DEPARTMENT OF NATURAL RESOURCES
John W. Hickenlooper, Governor
1120 Lincoln St. Suite 801
Denver, CO 80203
Phone: (303) 894-2100
FAX: (303) 894-2109
www.colorado.gov/cogcc

June 13, 2011

RE: TC Operating, LLC
Application for Deer Creek Disposal Facility
Deer Creek SWD #1 Underground Injection Control Well
NE $\frac{1}{4}$ NE $\frac{1}{4}$, Section 2, Township 14 South, Range 98 West, 6th P.M., Mesa County, CO

Figure 1 - Vicinity Map, Deer Creek SWD-1 Disposal Well Project

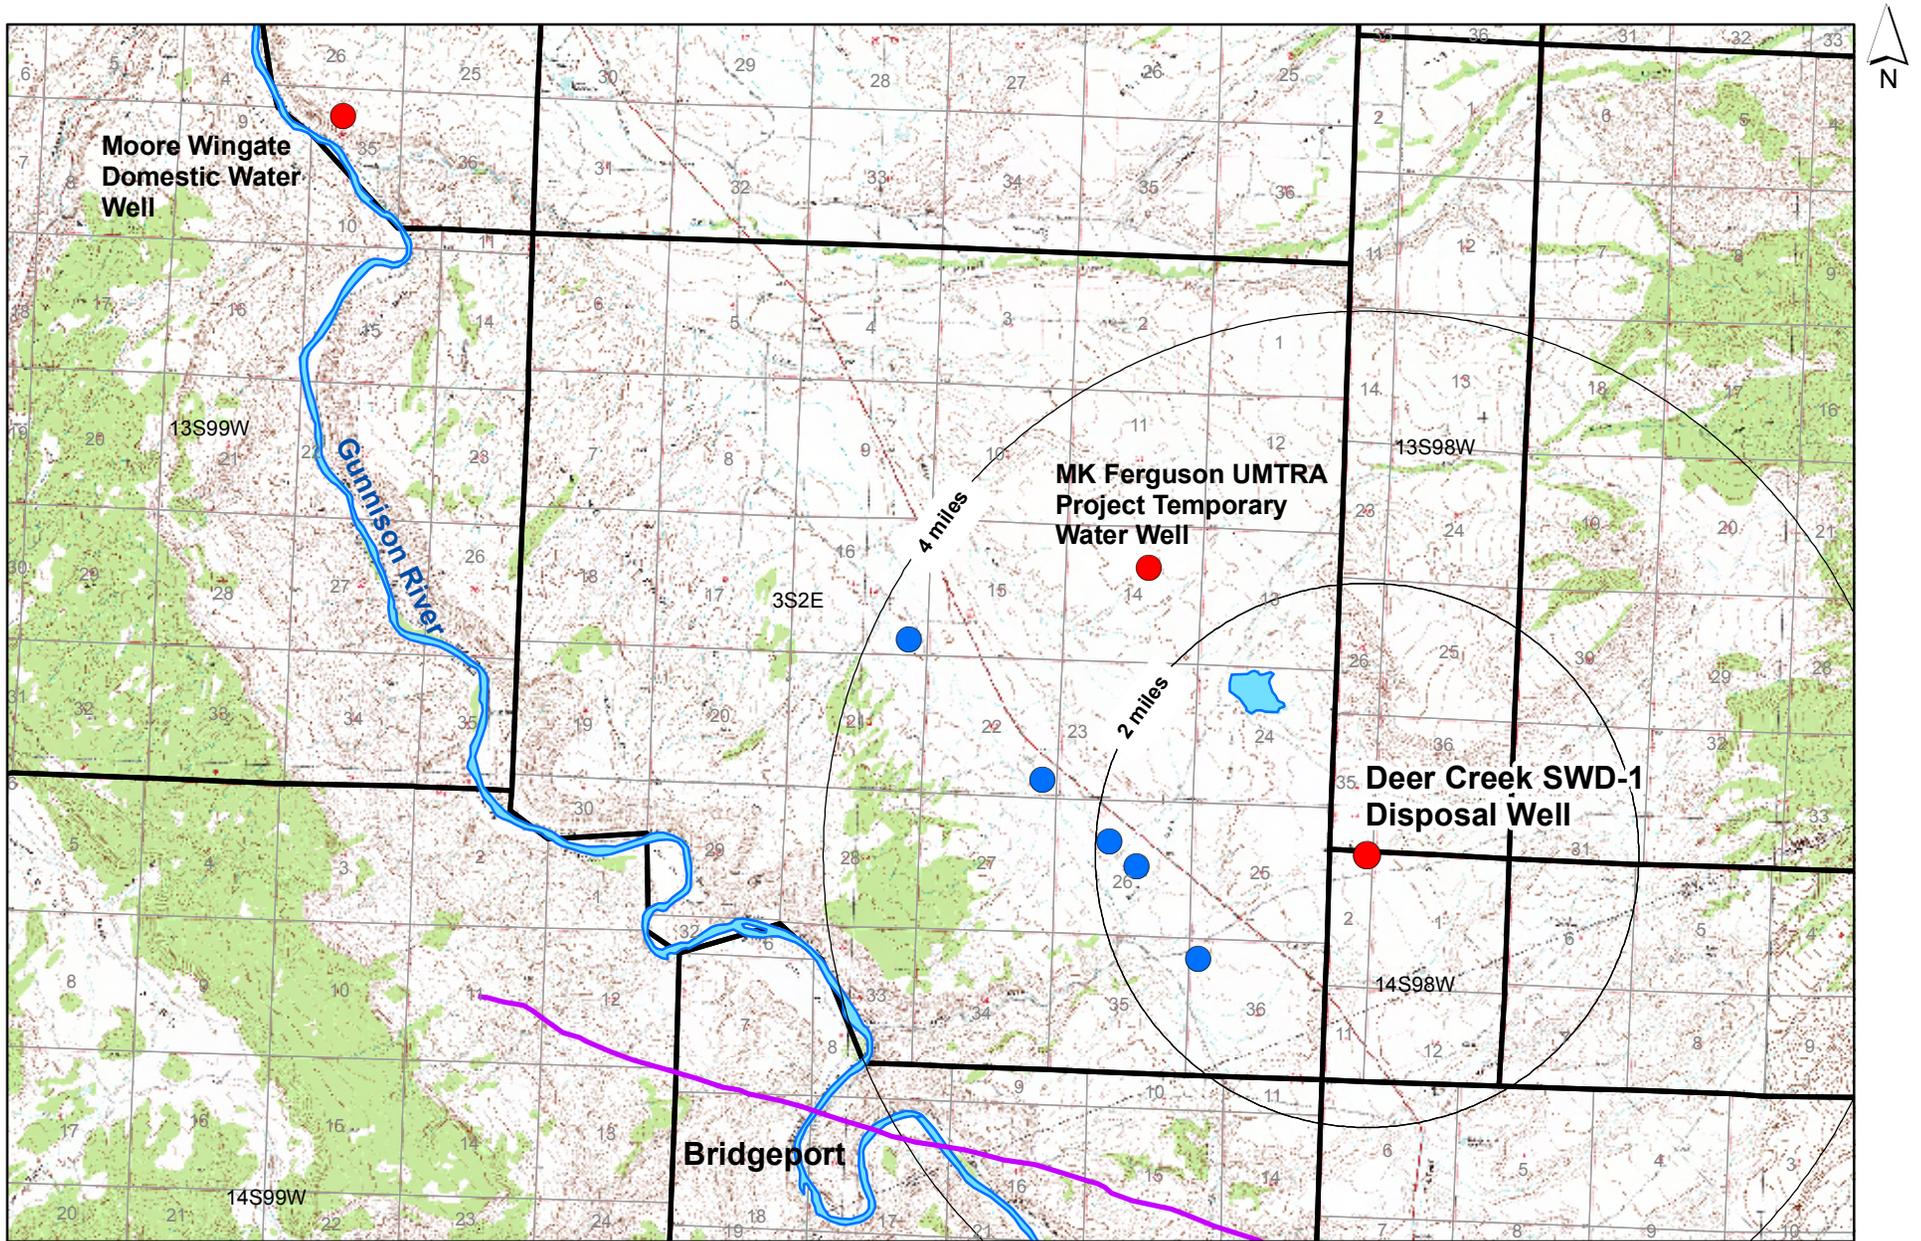
Shallow Depth. The proposed Injection Zone is within the unpermitted Wingate Sandstone at a depth between 1553 and 1766 feet below land surface (fbls). A Wingate injection zone has 691 feet of separation below the base of the Dakota Sandstone, which is used for domestic water supply in the area (see Figure 1). UIC Class II Wells in the State generally have thousands of feet of separation with multiple confining layers between the injection zone and overlying aquifers. In this case, the 691 feet of separation contains 2 other water-bearing sandstones: the Entrada (1426-1520 fbls) and Morrison Salt Wash (1220-1292 fbls) Sandstones. These sandstones present a problem because they provide a potential vertical permeability and fluid migration through the 691 foot “safety zone.”

Fractures. The Deer Creek SWD #1 well is located in an area that has undergone significant tectonic activity in the geologic past. The Uncomprahgre Uplift occurs just to the southwest of the Gunnison River (see Figure 1). It is therefore not surprising that a number of faults and fractures would be present in this area. A detailed geologic report for the UMTRA site in Section 14, Township 3South, Range 2 East indicates that fractures are prevalent in the area, even near the surface in the Mancos Shale (UMTRA report, September 1981). The report also indicates that new seismic activity, in the form of earthquakes, are possible in this area.

On May 31, 2011, COGCC Staff inspected the outcrops along the Gunnison River, near Bridgeport, at a location approximately 4.5 miles southwest of the Deer Creek SWD #1 well. A known fault exists at that location (see Figure 1). Several fractures and joints in the rock were observed in the Wingate and overlying sandstones. Figure 2a shows a large vertical fracture in the Wingate and Figure 2b shows a series of smaller fractures or joints in a sandstone unit that occurs above the Wingate (possibly the Entrada or Salt Wash).
